# **New measuring method for effective head restraint height**

**update of the method as a result of**

**the IWG on gtr No.7 in Dec. 2011**

**Hans Ammerlaan - Netherlands**

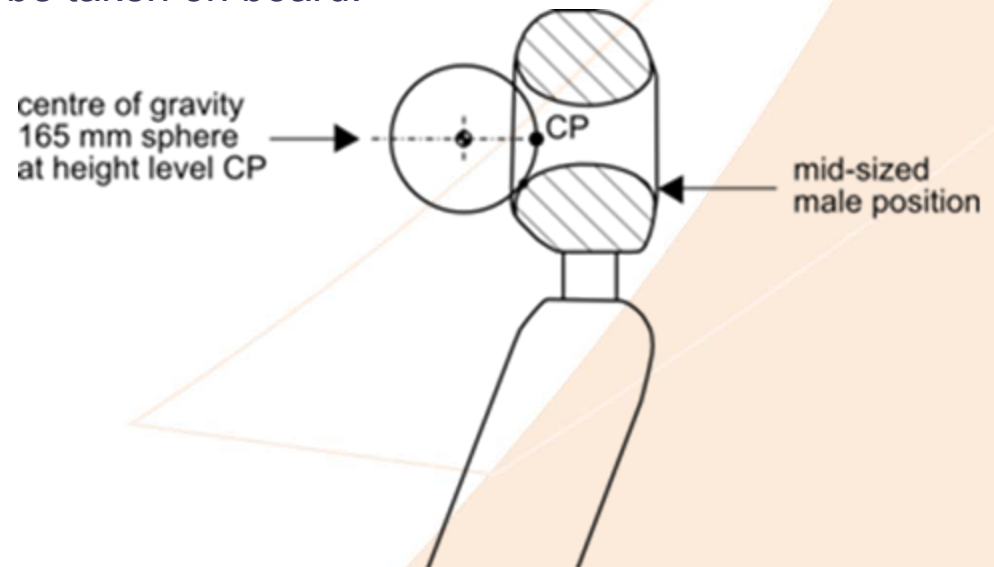
**Question:** how to do the measurement in case of gaps in the head restraint?

**Answer:** already in the task force this item has been discussed and in its report (May, 11th 2011) one alinea including a figure was dedicated to a solution. If this gap case is thought to give problems this solution can be taken on board.

To solve this item a figure (as given hereby) and an accompanying tekst have been introduced in Annex 1 and will be shown this London meeting  
(see resp. figure 1-5 and last alinea of paragraph 2.3.1.)
